From: David Whitworth [REDACTED]
Sent: Tuesday, March 08, 2016 1:03 PM
To: Dutton, Greg
Subject: Re: FW: Garage placement code amendment draft language

From: Dutton, Greg [mailto:Greg.Dutton@austintexas.gov]
Sent: Tuesday, March 8, 2016 11:42 AM
To: Dutton, Greg <Greg.Dutton@austintexas.gov>
Cc: Rusthoven, Jerry <Jerry.Rusthoven@austintexas.gov>; Guernsey, Greg <Greg.Guernsey@austintexas.gov>; Word, Daniel <Daniel.Word@austintexas.gov>; McDonald, John <John.McDonald@austintexas.gov>
Subject: Garage placement code amendment draft language

PROPOSED GARAGE PLACEMENT CODE CHANGE WILL HAVE NEGATIVE IMPACT

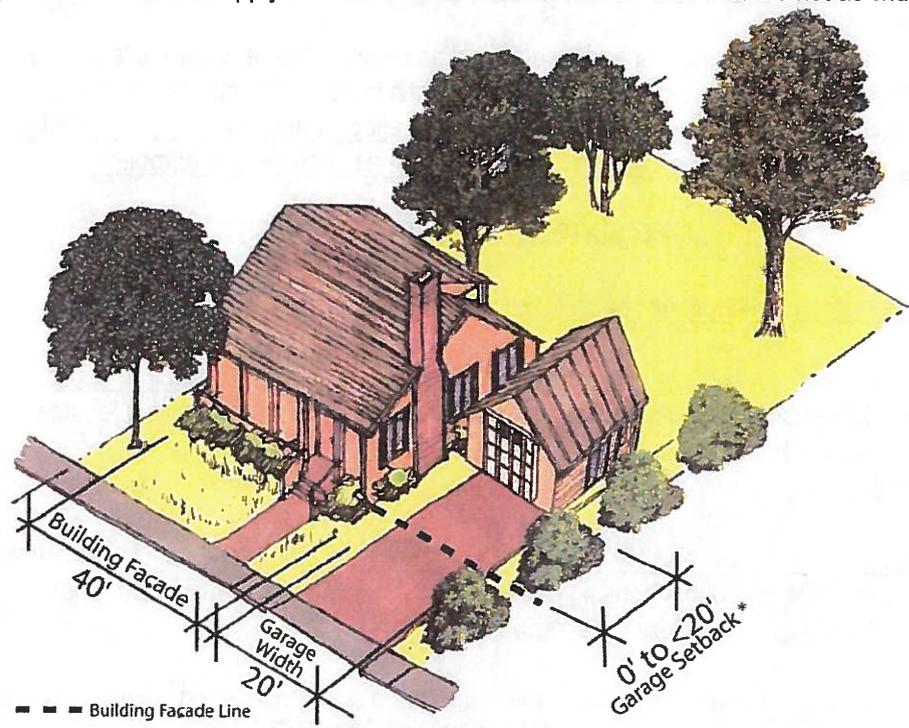
Example 1: A 30' wide cottage lot minus 10' of side setbacks results in a 20' wide home. Dividing by 3 results in 6.7' of possible garage/carport width, which is not wide enough for a single covered off-street parking space! **Smaller lots will be ineligible for covered parking entirely and this is not a fair, wise, or an intended result.**

Example 2: A 50' wide lot minus 10' of side setbacks results in a 40' home. Dividing by 3 results in 13.3' of possible garage/carport width, which means **many typical Austin lots will be limited to a single covered off-street parking space while two off-street parking spaces are required.**

- The allowable garage width should not be reduced from 1/2 of the house width to 1/3.
- Carpports, flag lots, duplexes, and lots less than 50' wide should be removed from any application of this tool. This allows more affordable housing options to better provide reasonable covered parking ie: small lots, cottage lots, urban homes, two-family homes & irregular shaped lots. The limitation on design is exponentially more difficult with these more affordable housing models.
- Remove "secondary apartments" and "single-family-attached" from staff proposal. These are some of the only ways left to develop more affordable housing options in Austin and making them more onerous to develop is against the Mayor's key goal of increasing affordable housing.
